May 31, 2022

Re: Inter Tribal Association of Arizona's Comments and Objections to ADEQ's Renewal and Amendment of the Resolution Copper Mining AZPDES Permit No. AZ0020389 (LTF No. 90471)

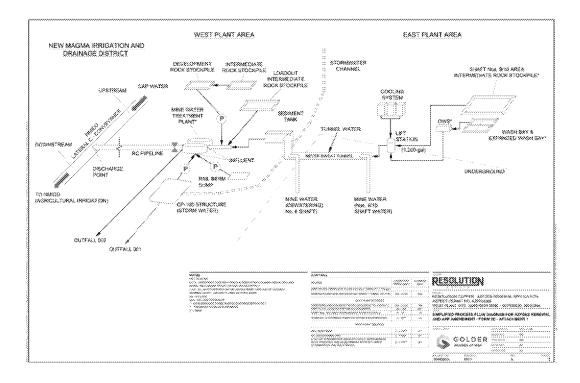
The Process Flow Diagram (shown on the following page) and Site Drainage Maps attached to the AZPDES Renewal Application⁹ indicate that stormwater from across the West Plant site drains to and is collected in Collection Pond No. 105 (CP-105, formerly "Indian Pond") where it can then be discharged through Outfall 001. The West Plant Site is located north of Highway 60 in Superior, just north of Queen Creek, and drains south towards Queen Creek.

In sum, there are multiple sites located across the West Plant site which have the potential to convey pollutants and other constituents of concern into Queen Creek via discharge of stormwater at Outfall 001.

The East Plant Site is east of the Town of Superior. The Process Flow Diagram (shown on the prior page) indicates that waters from various sources at the East Plant Site are collected and transported to the Water Treatment Plant at the West Plant Site through the Never Sweat Tunnel.

The Application at Form 2C(I) states that contributing flows to Outfall 002 come from "Various Combined Sources" such as "mine dewatering, stormwater, etc." and references an attachment. Yet, the attachments do not distinguish, or specifically list these various sources. Furthermore, there is no evidence from the materials we have reviewed that any sampling of the feed water from these various sources has occurred.

ADEQ should require that robust feed water quality data from these "various combined sources" at the East Plant Site be collected and analyzed for purposes of this permit. Data on the inflow into MWTP is essential to the ongoing functionality of the MWTP. ADEQ's failure to require this information is inconsistent with their mission and obligations in administering the Clean Water Act.
